HISTORIC AND DESIGN REVIEW COMMISSION

December 19, 2018

HDRC CASE NO: 2018-568
ADDRESS: 720 LAMAR ST
LEGAL DESCRIPTION: NCB 1653 BLK A LOT 10
ZONING: R-5
CITY COUNCIL DIST.: 2
DISTRICT: Dignowity Hill Historic District
APPLICANT: Daniel Plummer/North Gate Custom Builders
OWNER: Daniel Plummer/North Gate Custom Builders, Daniel Plummer/North Gate Custom Builders
TYPE OF WORK: Front yard fence
APPLICATION RECEIVED: December 10, 2018
60-DAY REVIEW: February 9, 2019
REQUEST:

EXAMPLE OF PROPOSED DESIGN

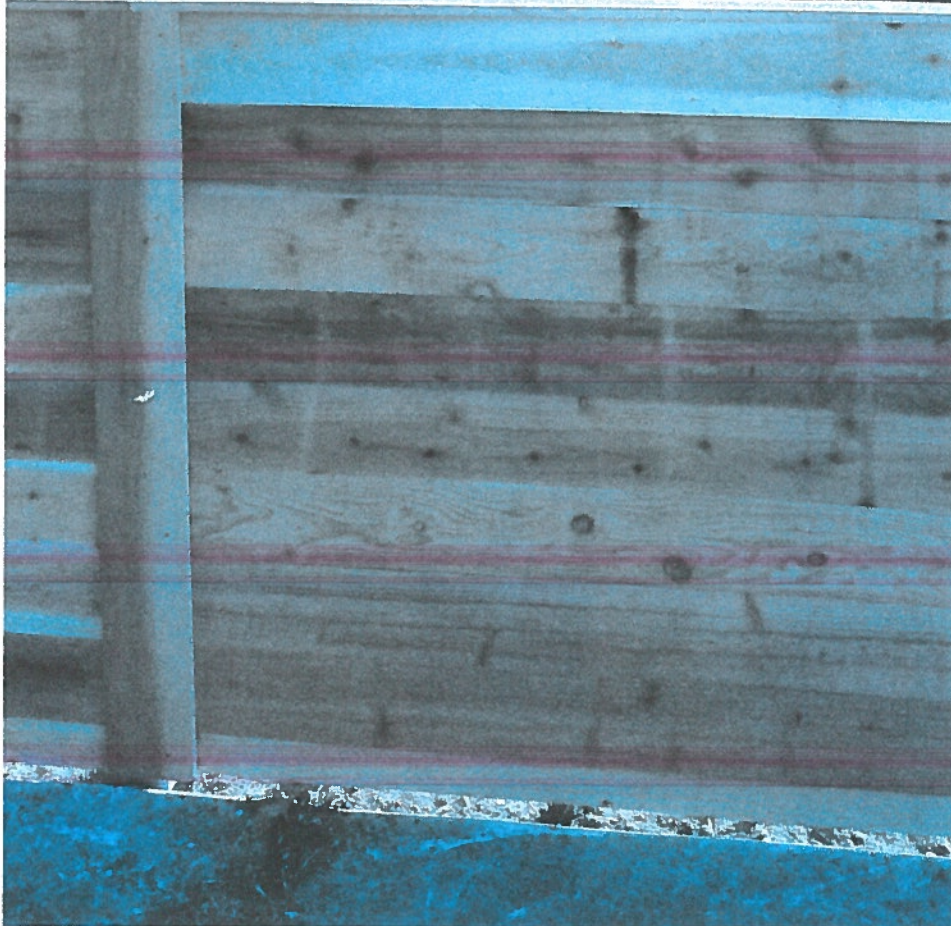
- c. FENCE LOCATION - The applicant has proposed to install a traditional wood picket fence that turns at the driveway to meet the corner of the house, instead of spanning across with a gate as originally proposed. According to the Guidelines for Site Elements 2.B.ii, new front yard fences should not be introduced within historic districts that did not historically have them. Staff finds that front yard fences are present on Lamar and in the Dignowity Hill Historic District. According to the Guidelines for Site Elements 2.C.i., privacy fences should be set back from the front façade to reduce their visual prominence. Staff finds that the fence should turn at the driveway to meet the corner of the structure, rather than spanning across the driveway as proposed. Staff finds that the driveway gate, if included, should be set back behind the front façade plane of the structure.

- d. FENCE DESIGN - According to the Guidelines for Site Elements 2.B.i., the design of the fence should respond to the design and materials of the primary historic structure or structures of a similar style in the neighborhood in relation to scale, transparency, and character. Staff finds that a wrought iron fence would be the most appropriate in context of the two flanking historic structures both featuring wrought iron fences and along Lamar. However, staff also finds that the simple traditional wood picket fence relates may also be appropriate for this home which features new construction.

- e. REAR GATE – The applicant has proposed to install a rear pedestrian gate featuring vertical wood pickets and four feet in height to match the proposed front yard gate and to be located behind the front façade plane of the home in the driveway. Staff finds that the proposed rear gate is appropriate in design and location.

- f. LANDSCAPE – The applicant has proposed to install xeriscaping in the front yard to include crushed granite, ground plantings, and trees. The lot originally featured natural turf prior to being prepared for new construction. Per the Guidelines for Site Elements 3A. and B., natural plantings should not be reduced by more than 50% and low ground plantings should be incorporated into the design when xeric or hardscaping is introduced. Staff finds that the proposed design does feature an appropriate amount of plantings.

- i. That no portion of the front yard fence is taller than four feet in height.
- ii. That a driveway gate, if included, is set behind the front façade plane of the home, features a design similar to the front wood picket or the rear privacy fence, and that no portion is taller than six feet in height.
- iii. That the xeriscaping plan feature the simple poured concrete central walkway, does not introduce additional pavers, and retains at least 50% of natural ground cover or tree canopy.
